TRAFFIC SIGNAL
ILLINOIS ST AT TERRY A.
FRANCOIS BLVD - MARIPOSA ST
MISSION BAY BLOCKS 33-34
MISSION BAY PROJECT, SAN FRANCISCO, CA

SHEET
T2.1

TRAFFIC SIGNAL EQUIPMENT AND CONDUCTOR SCHEDULES - ILLINOIS ST AT TERRY FRANCOIS BLVD MISSION BAY BLOCKS 33-34

SHEET T2.2

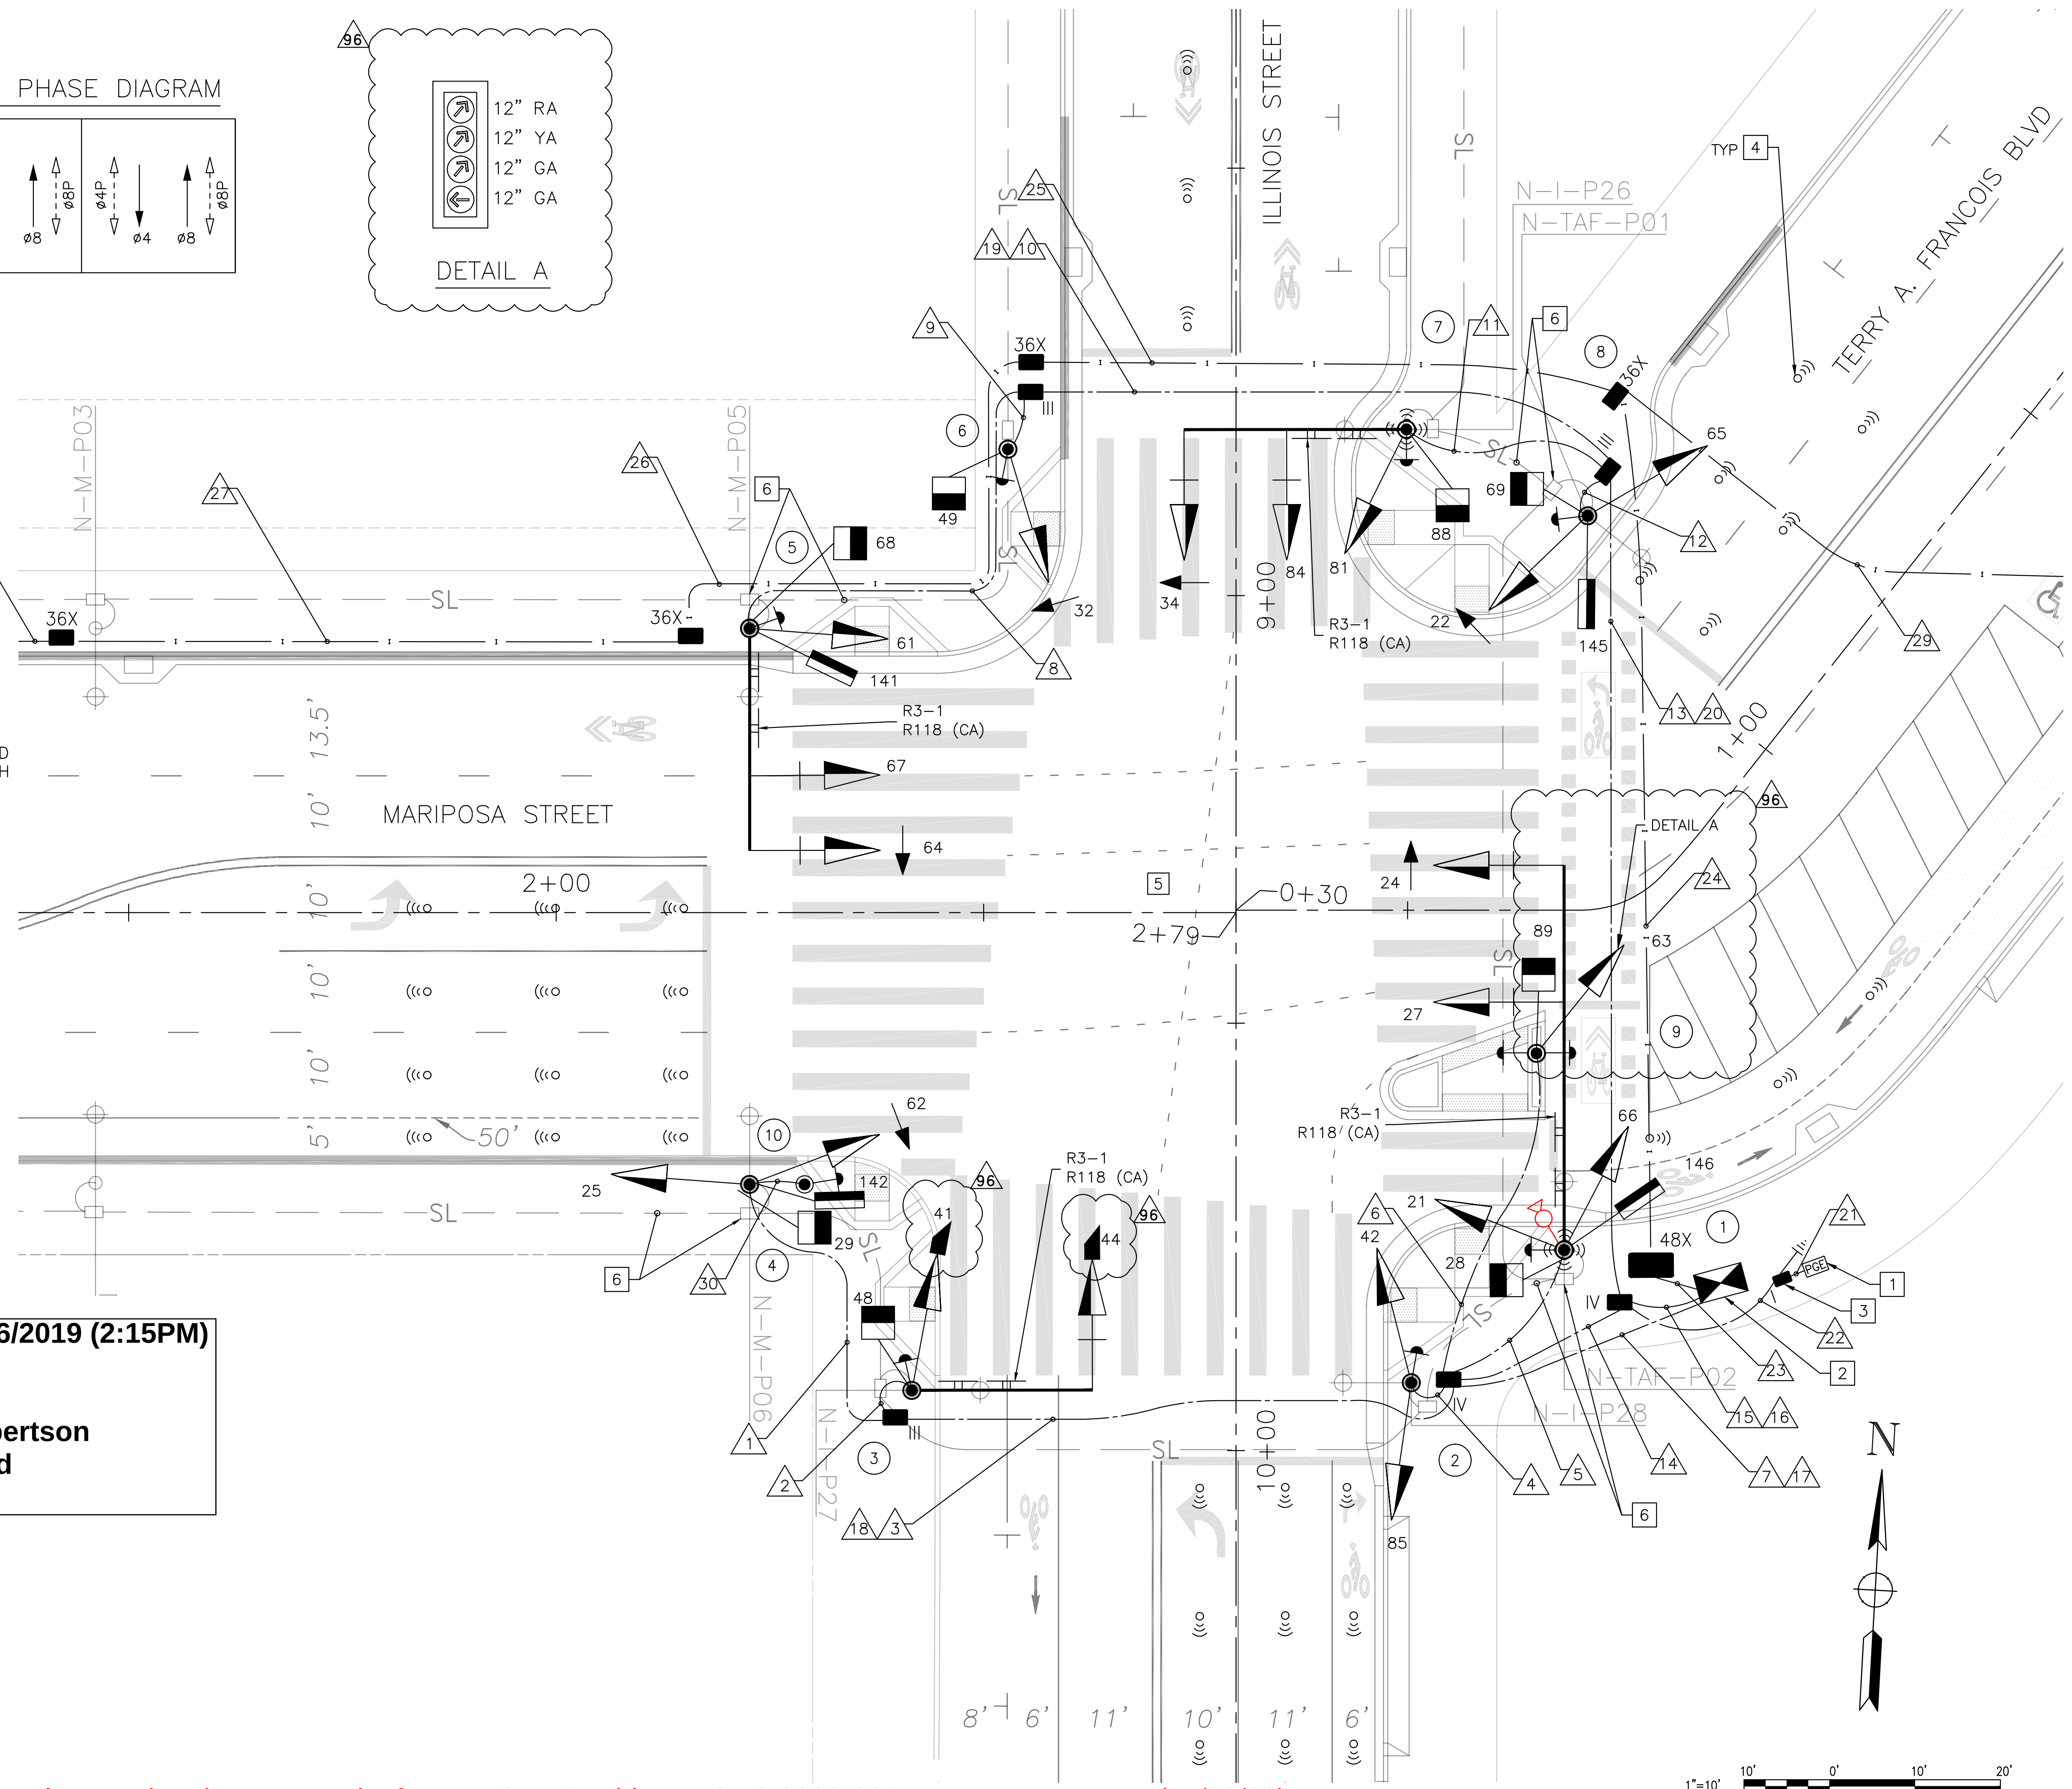
Added CCTV on Pole 1, updated Runs 5 and 7 for new CAT 6 cable per SRC 2023-266 - J. Lee, L. Ventura (11/30/23)
